Subject: Submittal of Additional Information Concerning Remediation Activities at the
Westinghouse, Waltz Mill Site, Madison, Pennsylvania
License No., SNM-770, Docket No. 07000698

**Response to NRC Letter Dated August 10, 2001
Request for Additional Information
Concerning Remediation Activities**

**Waltz Mill Site
Madison, Pennsylvania**

**Response to NRC Letter Dated August 10, 2001
Westinghouse Electric Company, LLC
Request for Additional Information
Concerning Remediation Activities at the
Westinghouse Waltz Mill Site
Madison, Pennsylvania**

Groundwater Radiochemistry Isoconcentration Maps

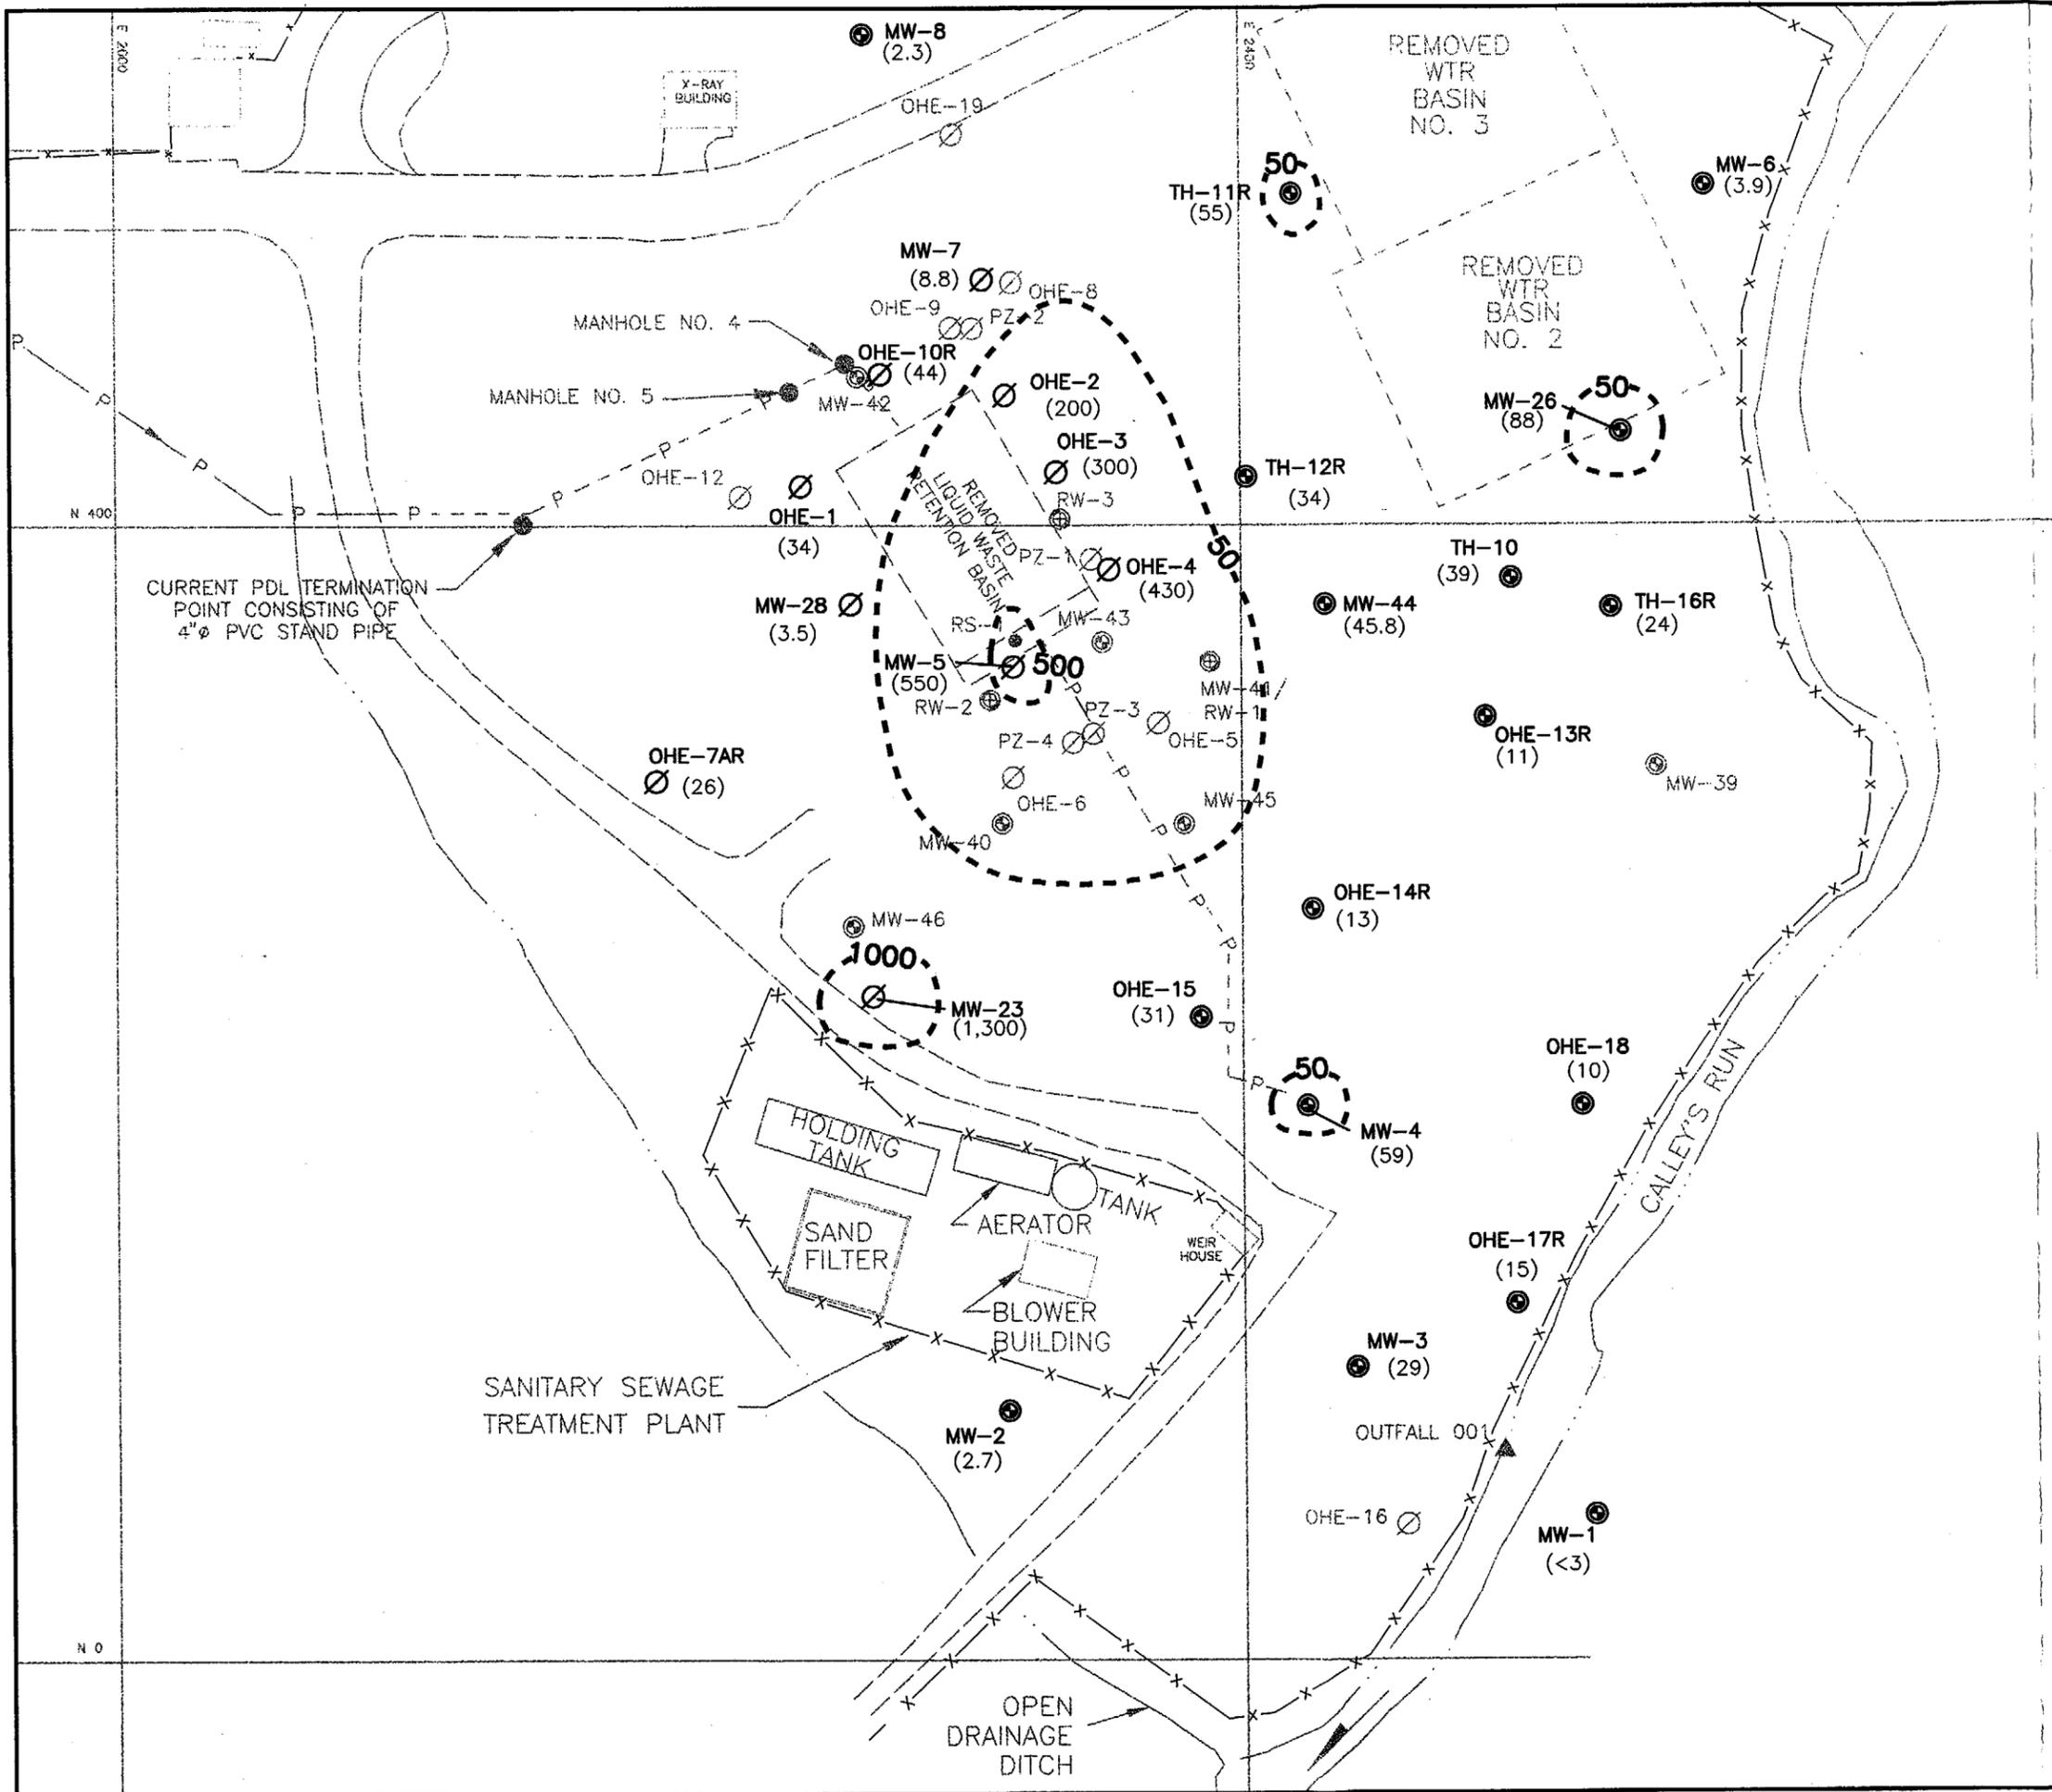
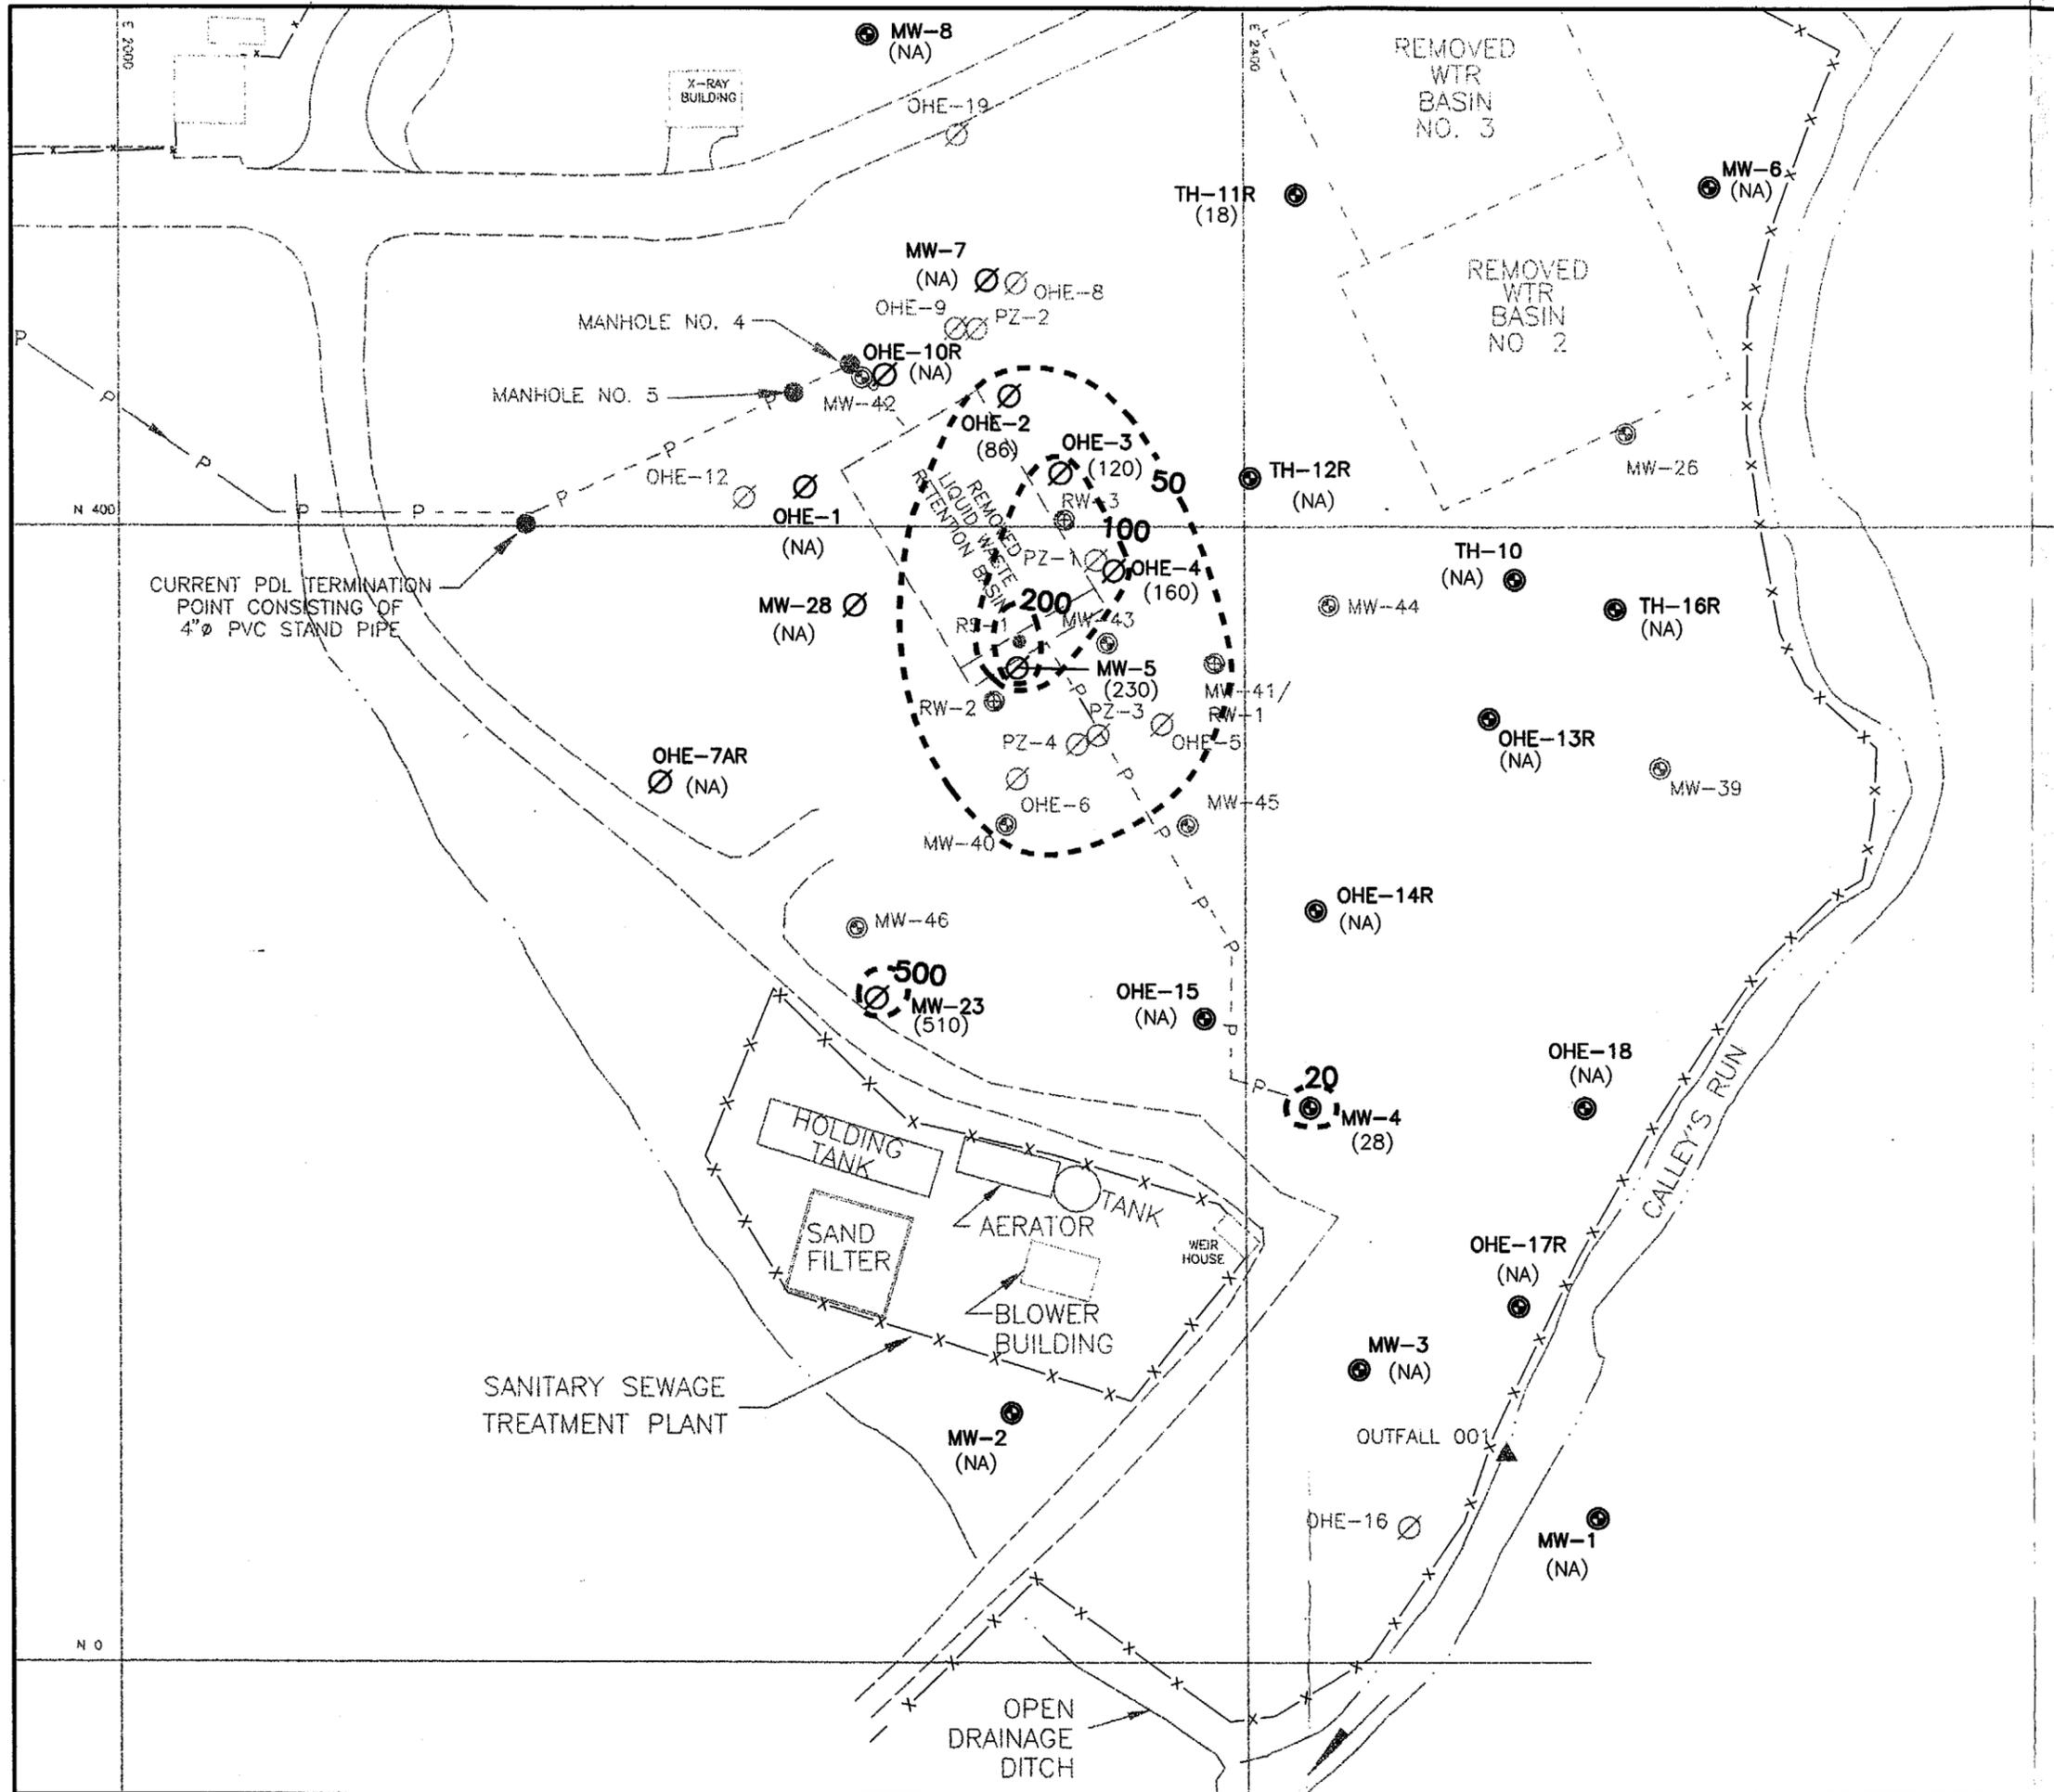
Question No. 4c: In order to evaluate radiochemical data trends for your onsite monitoring wells, please provide radiochemical data obtained since 1999. If possible, please provide the most current map of the groundwater plume configuration, compared to plume configurations measured in the past. Also, please explain the rise in the Sr-90 concentration in Well MW-5 during 1999 from 330 to 575 pCi/liter.

Initial groundwater quality data from the newly installed monitoring and remediation wells have been collected and evaluated. Updated groundwater radiochemistry maps were prepared and are included in Attachment C for comparing preremediation and postremediation groundwater plume conditions. Historical groundwater plume maps were presented in the June 22, 1999 license amendment. Figure C-1 and Figure C-2 illustrate the gross beta/gamma and Sr-90 groundwater plumes before the start of remediation activities (December 1996). Figures C-3 and C-4 illustrate the gross beta/gamma and Sr-90 groundwater plumes based on initial groundwater quality obtained following the completion of soil remediation activities within the liquid waste retention basin area (August 2001).
